### ADDENDUM 1

## Austin Elementary School Heating & Air Condition (HVAC) Improvements Funded through the Elementary & Secondary Emergency Relief (ESSER) Funds May 31, 2022

## Addendum

**PROJECT** 218007.004 | Edinburg CISD - Stephen F. Austin ES - HVAC Improvements

**4** A/C CLOSET - RESOURCE ROOM  
 M3.01 1/2" = 1'-0"

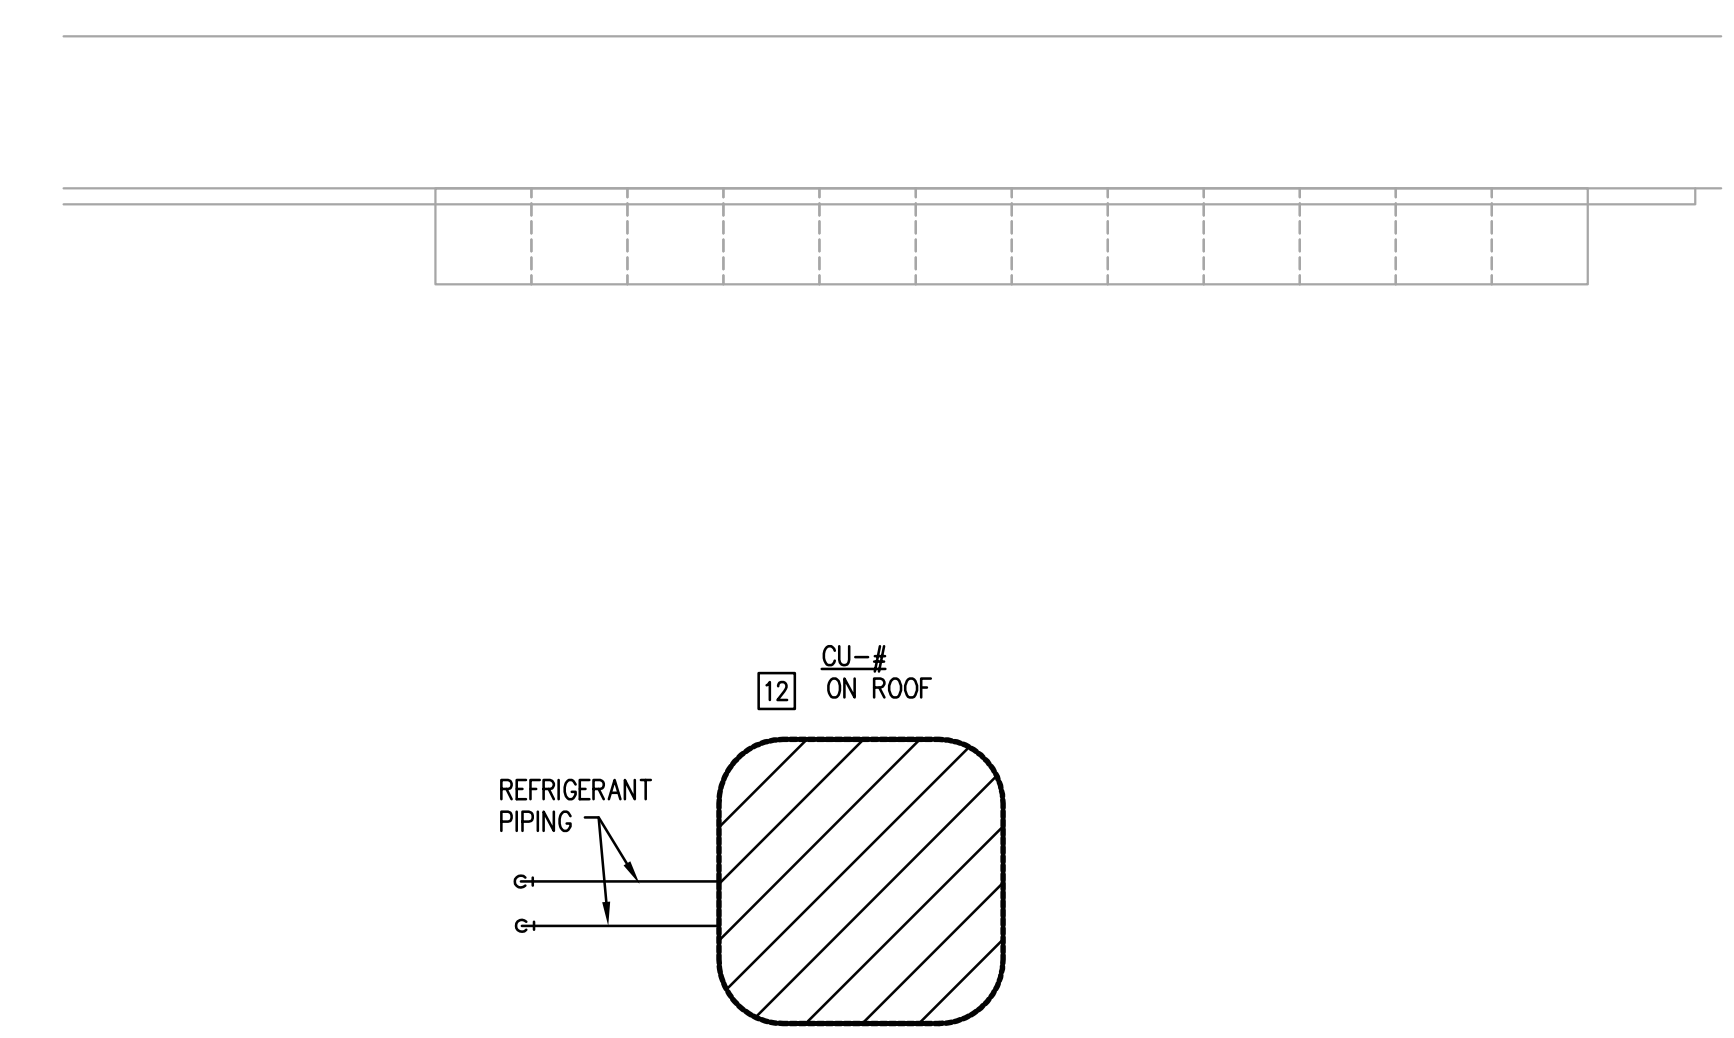
**Item 09 M3.01 – Enlarged Mechanical Plan**

- A. Revised keyed note 7.
- B. Indicate volume dampers

SHEET NUMBER:  
**M3.02**

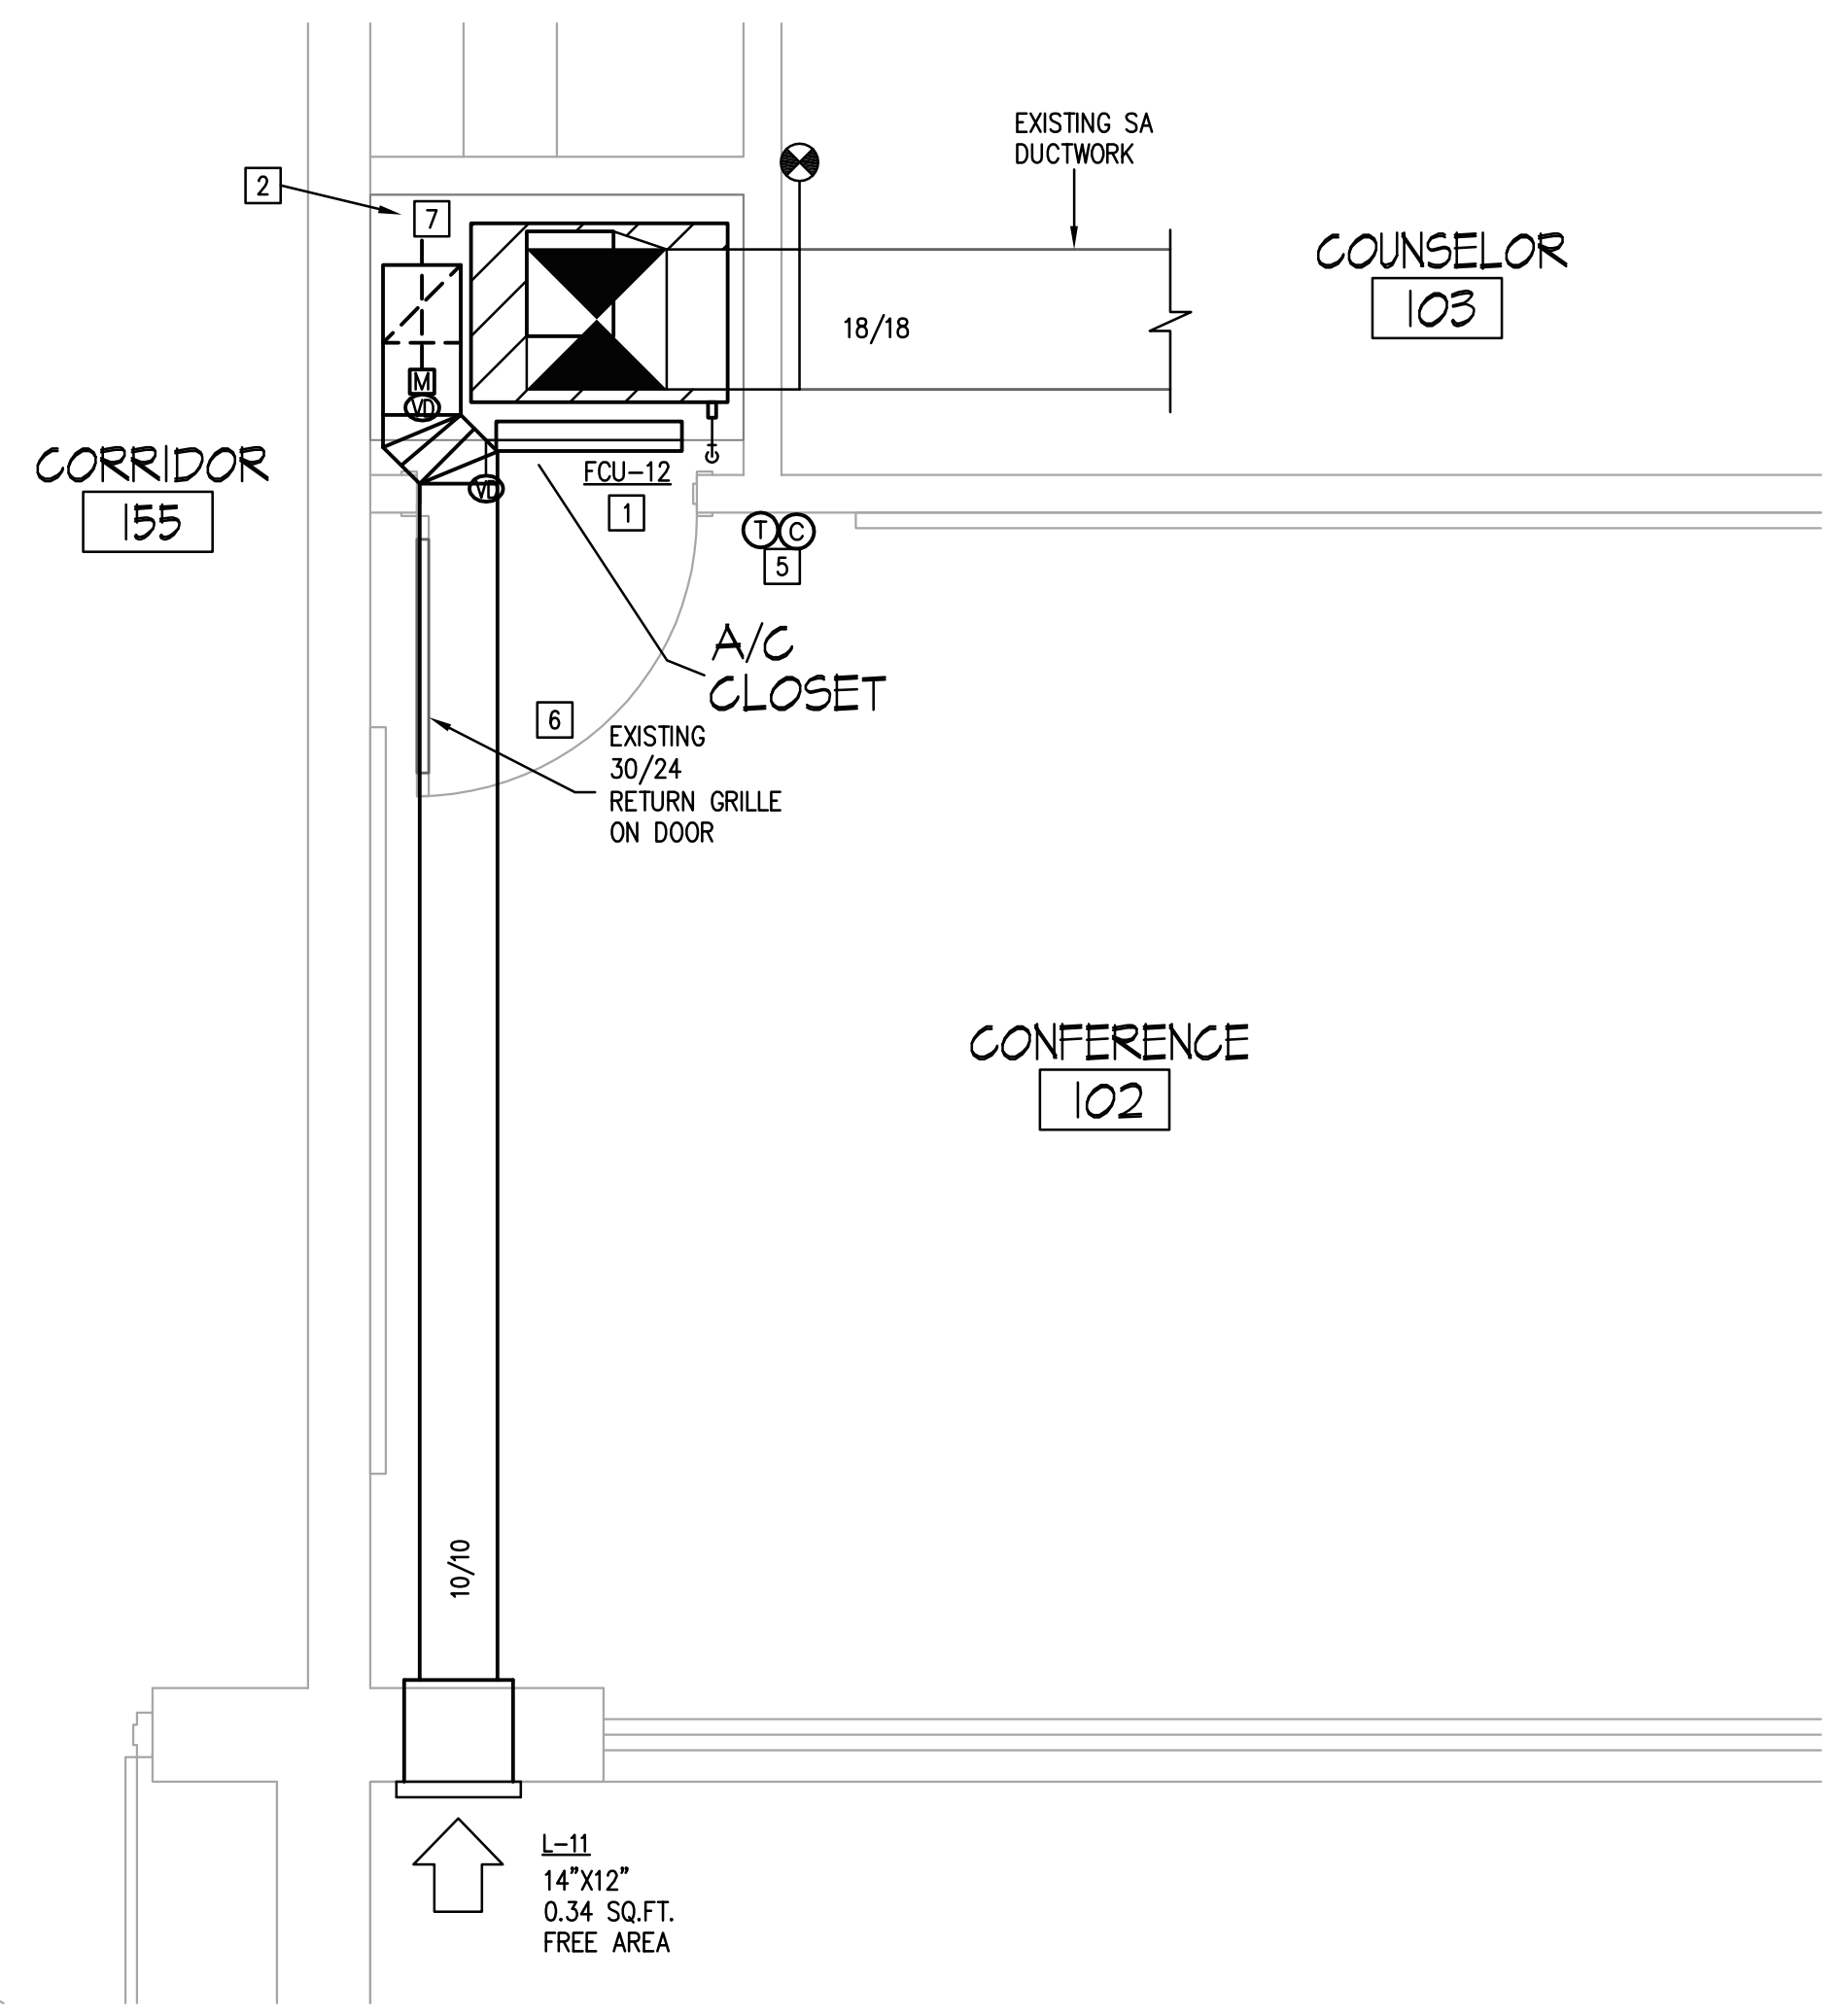
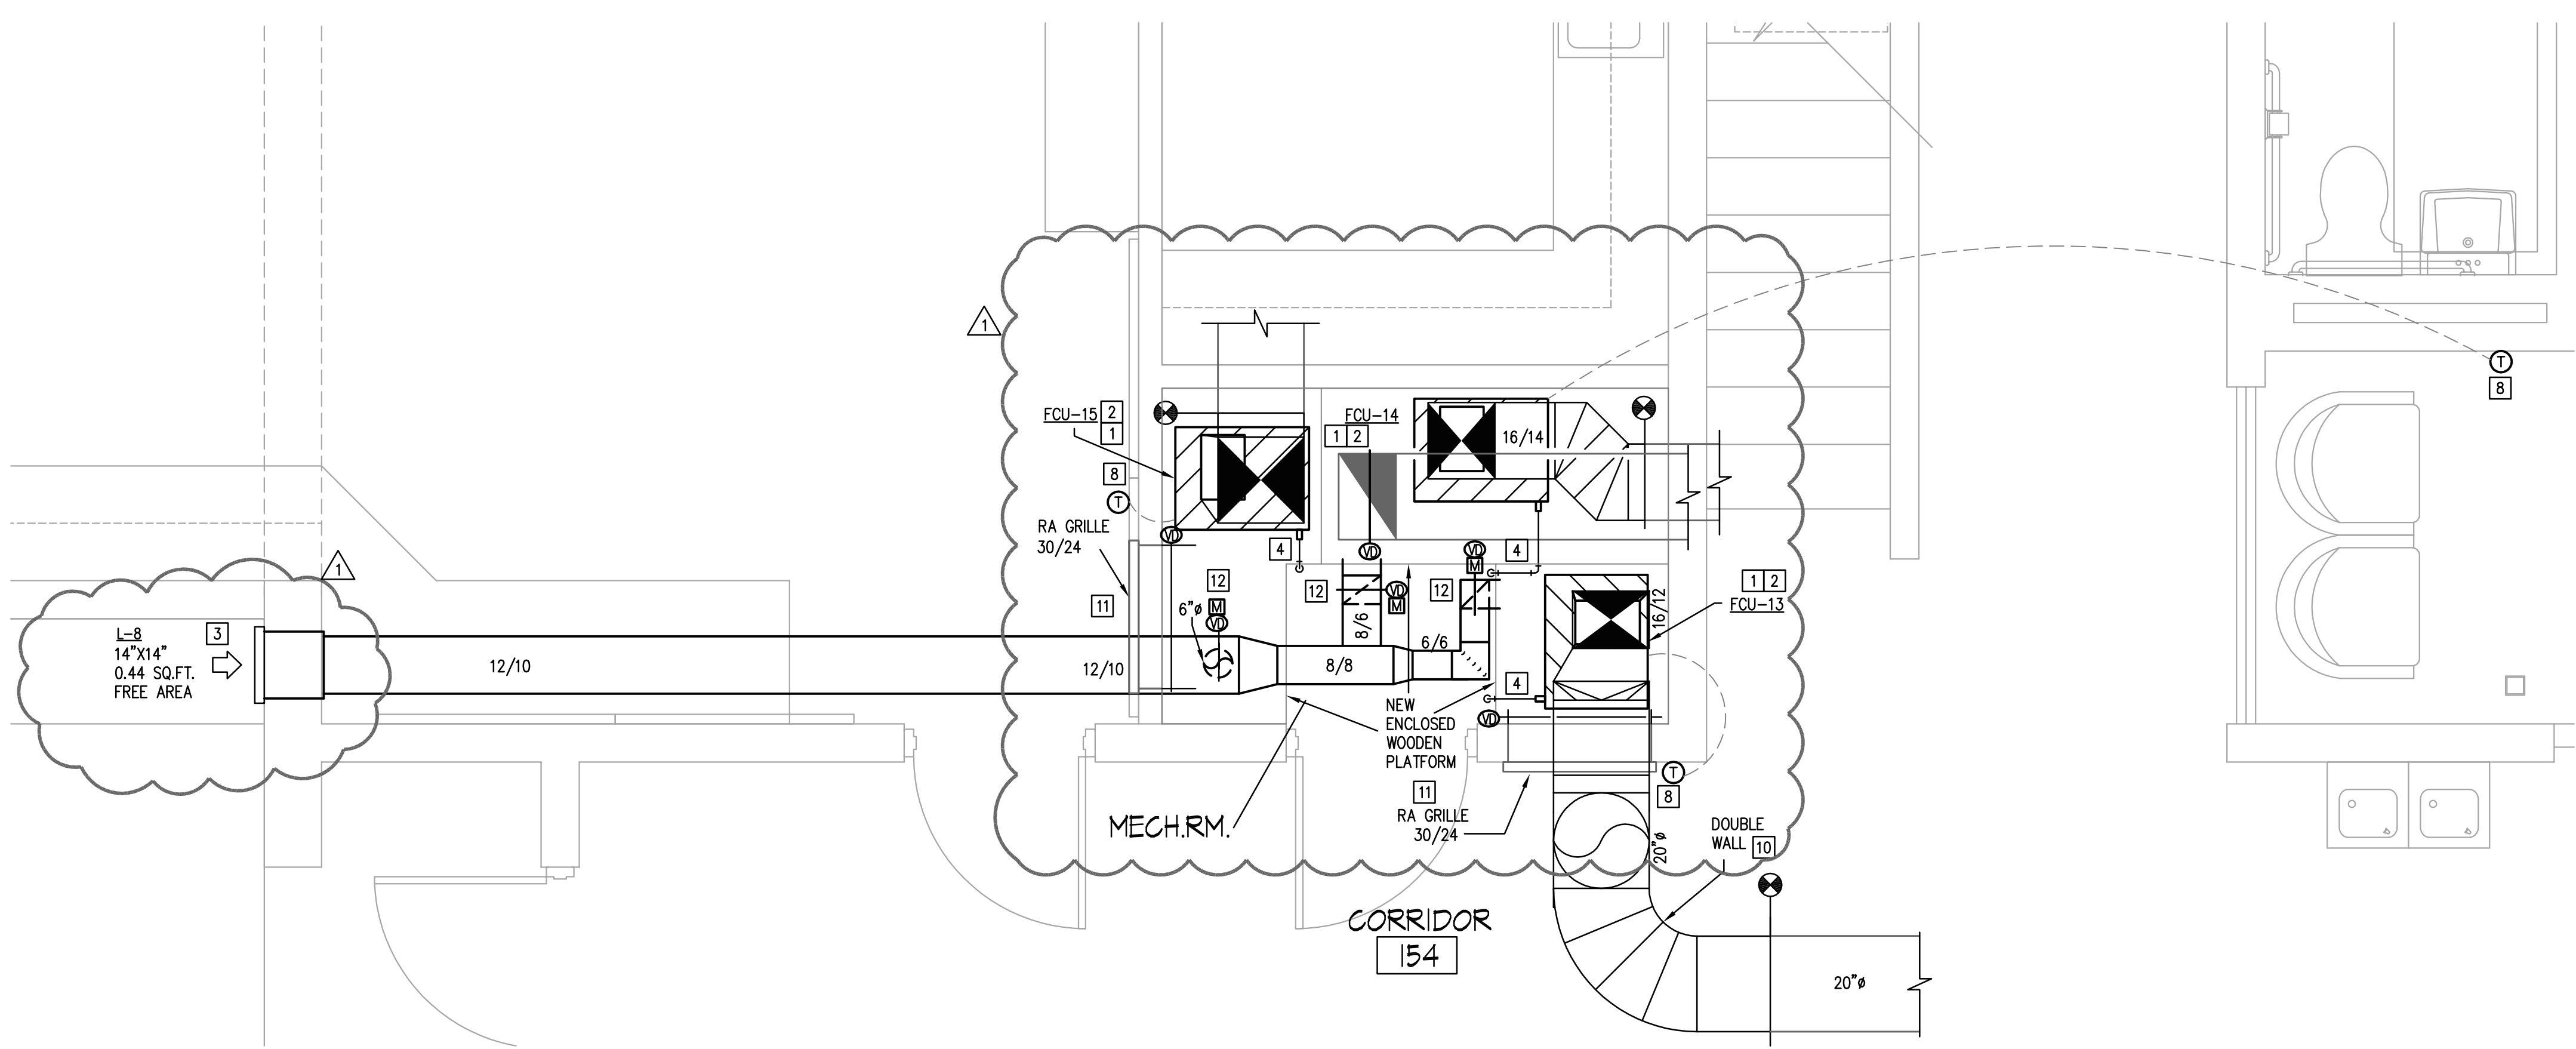
**Item 10 M3.02 – Enlarged Mechanical Plan**

- A. Revised keyed notes 2, 7, 9, 11, 12.
- B. Revised Louver L-8 size.
- C. Indicate outside air routing to each fan coil unit in Mech. Rm in 3/M3.02.
